**Subject: Sweetwater Uranium Project – Docket Number: 40-8584  
Source Material License SUA-1350 - Sweetwater County, Wyoming –  
Replacement Map – 2015 Corrective Action Program (CAP) Review**

**SWEETWATER URANIUM FACILITY**  
**SPRING PIEZOMETRIC CONTOUR MAP**  
**2015 CORRECTIVE ACTION PROGRAM REVIEW**

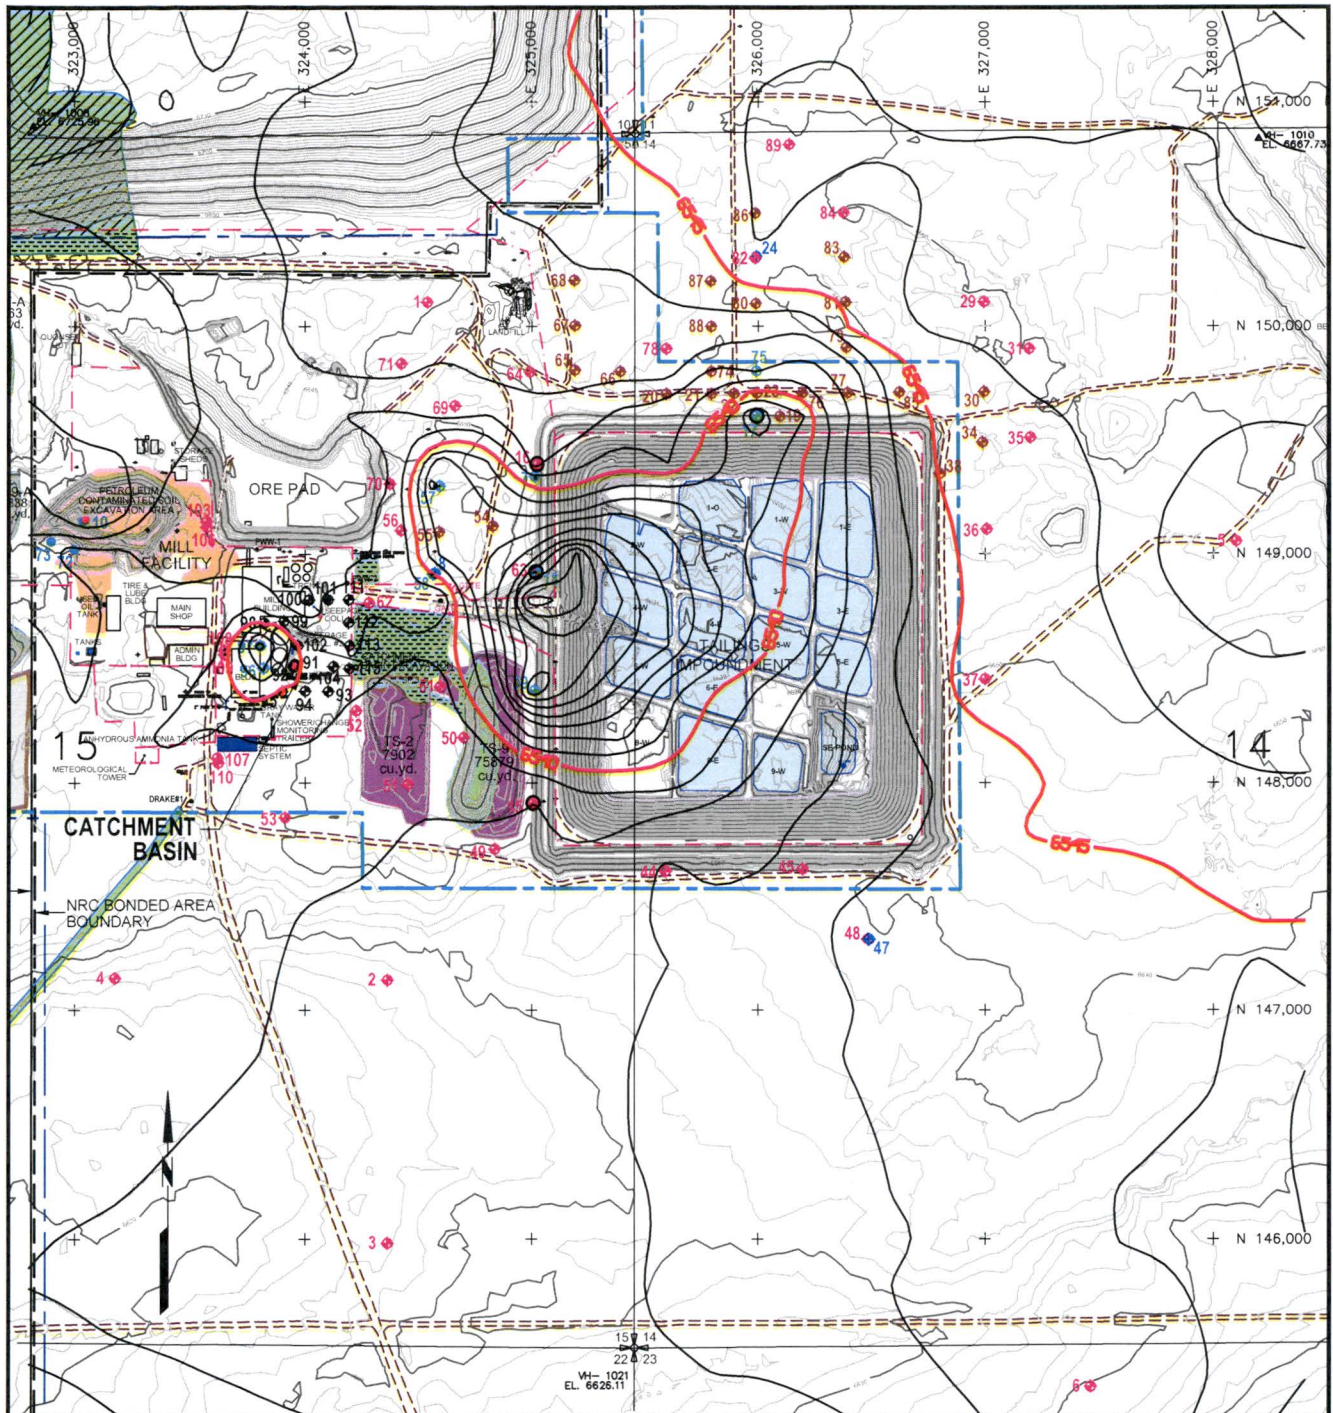
Attached please find a map entitled *Sweetwater Uranium Facility – Spring Piezometric Contour Map – 2015 Corrective Action Program Review*. Please replace the map currently in the document with this corrected map. The contours were inadvertently omitted (the contour layer was turned off) on the map submitted with the original document on February 24, 2016.
